UNITED STATES PATENT AND TRADEMARK OFFICE

APPLICATION NO.	FILING DATE	FIRST NAMED INVENTOR	ATTORNEY DOCKET NO.	CONFIRMATION NO.
09/437,296	11/09/1999	MICHIO YAMAJI	991283	7789

Office Action Summary	Application No. 09/437,296	Applicant(s) YAMAJI ET AL.	
	Examiner Aaron M Dunwoody	Art Unit 3679

DETAILED ACTION***Continued Examination Under 37 CFR 1.114***

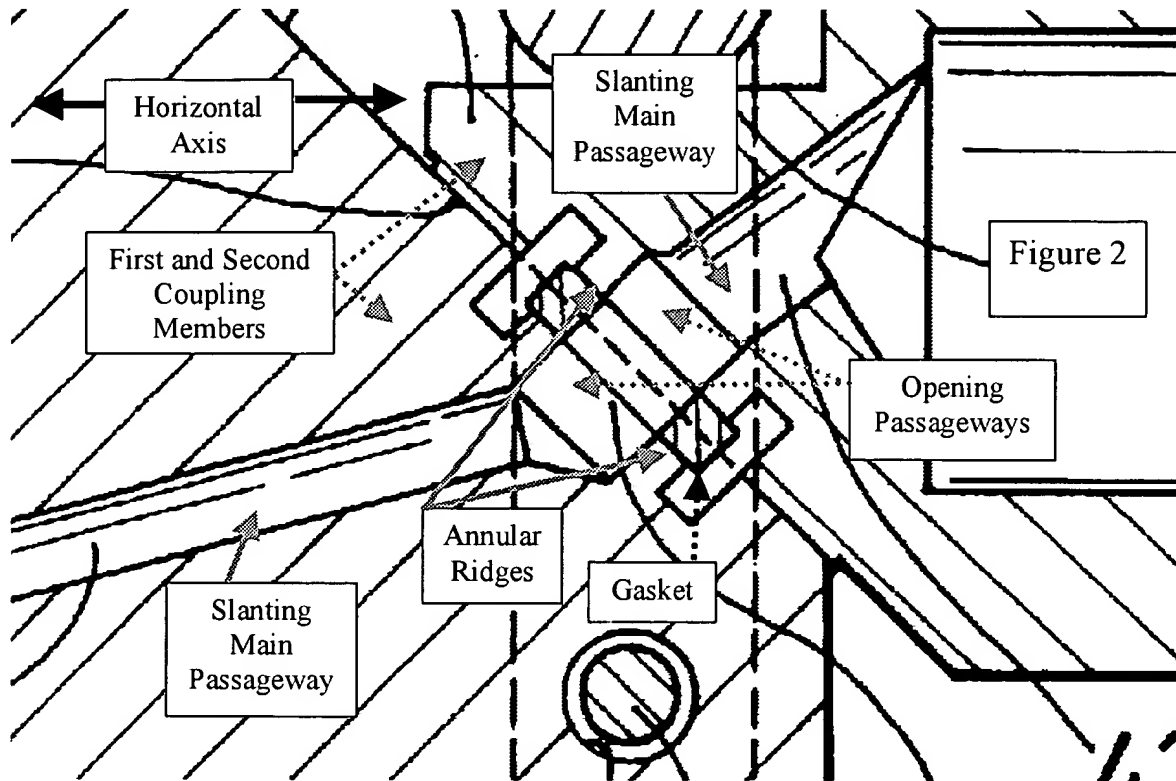
In regards to claim 1, in figure 2 below, as best understood, Nakazawa et al discloses a fluid coupling comprising first and second coupling members having respective gasket holding annular ridges on butting end faces thereof; and

an annular gasket interposed between the first and second coupling members, wherein each coupling member has a fluid channel comprising an opening passageway orthogonal to the butting end face thereof, and a slanting main passageway communicating therewith, the opening passageway having a diameter equal to the inside diameter of the gasket holding annular ridge, and

the gasket holding annular ridges are in contact with the gasket at its radial midportion so as (capable) to relieve the inner peripheral portion of the gasket from stress concentration and wrinkles.

Nakazawa et al does not disclose the gasket holding annular ridges being rounded as to be in contact with the gasket only at its radial midpoint. In Figure 6, McGarvey teaches gasket holding annular ridges (76, 78) being rounded as to be in contact with the gasket (52) only at its radial midpoint to produce a minimum dead zone volume condition (col. 1, lines 45-64). As McGarvey relates to face-seal fitting employing a metal gasket, it would have been obvious to one having ordinary skill in the art the time the invention was made to fabricate rounded gasket holding annular ridges as to be in contact with

the gasket only at its radial midpoint to produce a minimum dead zone volume condition, as taught by McGarvey.
